Access Compliance Report

Public Rights-of-Way

(Curb Ramps)

Intersection ID: 48944	Main Street: LILLYSHIRE_PL	Cross Street: CALDWELL_RIDGE_PY	Location: W
ADA ID: C000F51E3B3B	Ramp Type: BlendTrans1	Initial Pass/Fail: Fail	Overall Compliance: No
Severity Score: 8.75			
Codes/Mitigation Info/Possible Solution		Field Measurements/Component Compliance

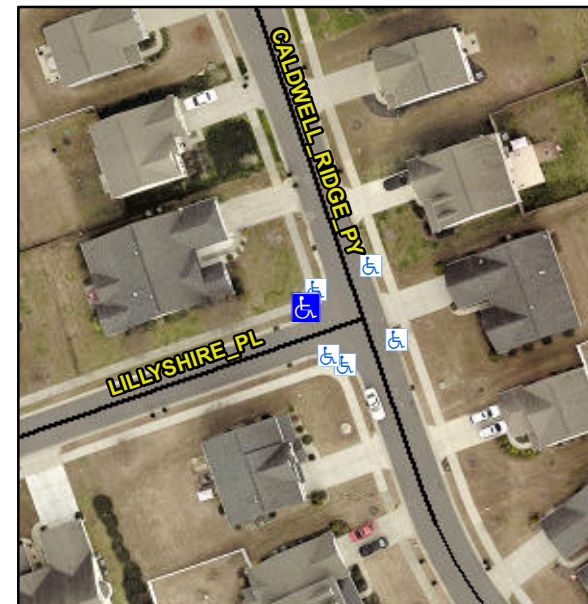
CURB GAP 1.0

Not Found, R304.5.1

Remove & Replace Curb Ramp With Two New Directional Ramps or Equivalent.
